car stereo Service Bulletin No.81

Model: CDX-A10

Subject: Disc Magazine Jams In The Unit
During Eject

Bottom view of XA-10B

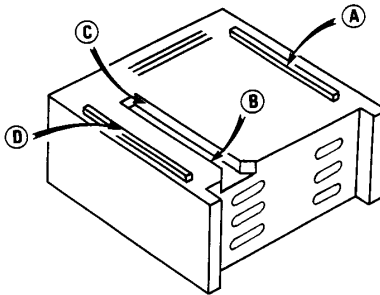
When using the XA-10B disc magazine in the unit, the magazine may get stuck during eject.

Lubricate the guide slots on the XA-10B magazine using the following procedure:

1. Lubricate the four guide slots (A-D) shown in the diagram with a small amount of silicon oil (P/N 7-661-012-15) using an applicator (cotton swab, etc).
2. Leave as is for one minute.
3. Wipe the applied oil with a cloth.
